Access Compliance Report

Public Rights-of-Way

Intersection ID: 21151	Main Street: CARMEL_RD	Cross Street: MULLENS_FORD_RD	Location: NW
ADA ID: 6EEC0EEBFDF6	Ramp Type: PerpDiag	Initial Pass/Fail: Fail	Overall Compliance: No
Severity Score: 12.5			
Codes/Mitigation Info/Possible Solution		Field Measurements/Component Compliance

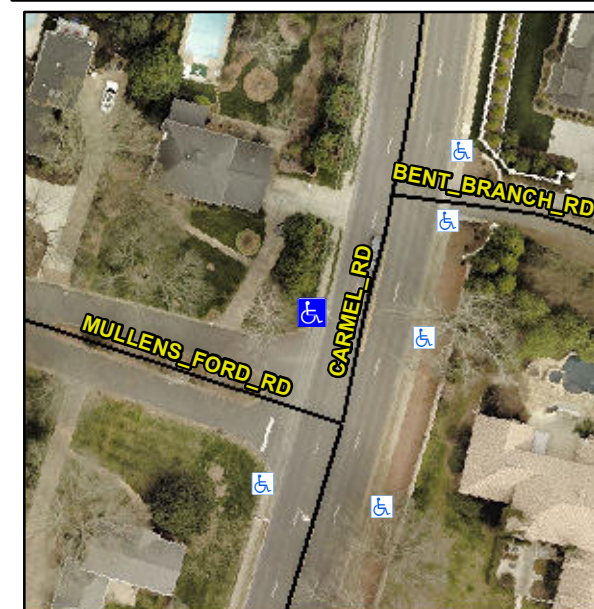
Not Found, R304.2.2

Compliance	Description	Data	Compliance	Description	Data
N/A	Ramp Length (in)	41.0	No	Ramp Slope (%)	10.2
Yes	Ramp Width (in)	48.0	Yes	Ramp XSlope (%)	2.0
N/A	Flare Type LT	N/A	N/A	Flare Type RT	N/A
N/A	Flare Slope LT (%)	N/A	N/A	Flare Slope RT (%)	N/A
N/A	Flare Traversable LT?	N/A	N/A	Flare Traversable RT?	N/A
N/A	Landing Length (in)	N/A	N/A	DWS Provided?	N/A
N/A	Landing Width (in)	N/A	N/A	DWS Contrast?	N/A
N/A	Landing Slope (%)	N/A	N/A	DWS Length (in)	N/A
N/A	Landing X Slope (%)	N/A	N/A	DWS Full Width?	N/A
N/A	Landing Curb? (Y/N)	N/A	N/A	DWS Offset (in)	N/A
N/A	Shared Landing?	N/A			
N/A	Gutter Ponding?	N/A	N/A	Gutter Slope (%)	N/A
N/A	Gutter Lip Ht (in)	N/A	N/A	Gutter X Slope (%)	N/A
N/A	Painted X Walk1?	No	N/A	Painted X Walk2?	No
	X Walk 1 Direction	To SW		X Walk 2 Direction	To SE
N/A	X Walk 1 Width (in)	N/A	N/A	X Walk 2 Width (in)	N/A
	X Walk 1 Slope (%)	0.9		X Walk 2 Slope (%)	2.2
	X Walk 1 X Slope (%)	5.9		X Walk 2 X Slope (%)	1.9

Remove & Replace Curb Ramp With Two New Directional Ramps or Equivalent.
